Planning, Land Use and Mobility Committee

CASE REPORT ZA-2022-2788-CU-SPP-SPR-WDI IN-N-OUT Burgers 22822 West Ventura Blvd. Woodland Hills, 91364

PLUM Presentation:

Aerial view showing project site, adjacent properties and the "alley" that is unused. The project proposes landscaping the "alley" and shutting off all access.

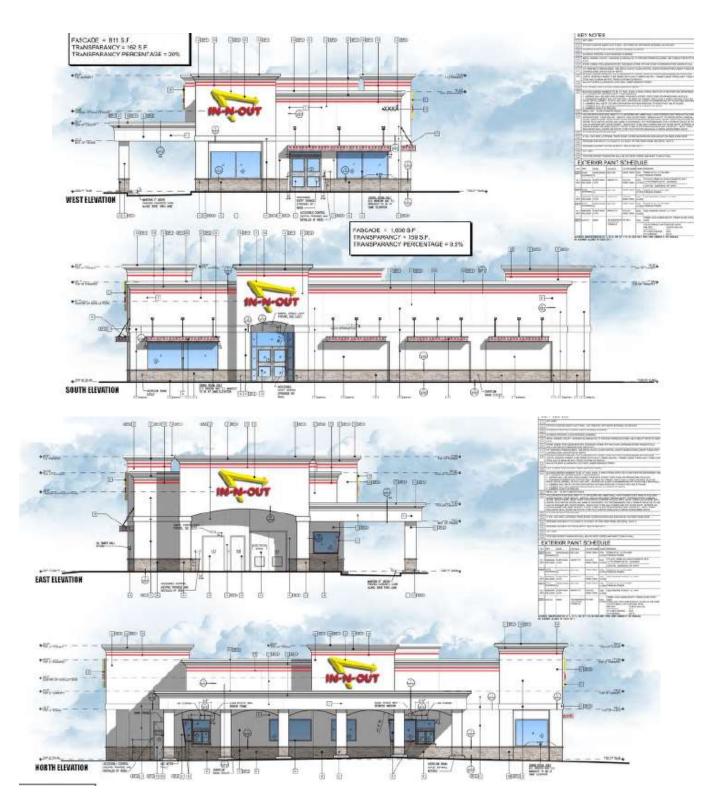
- 2. What is the purpose of the conversion of the alleyway off Fallbrook into a landscaped area? Does it make sense to have plants, trees, grass there considering the drought situation? Does the Applicant need to take another look at this area?
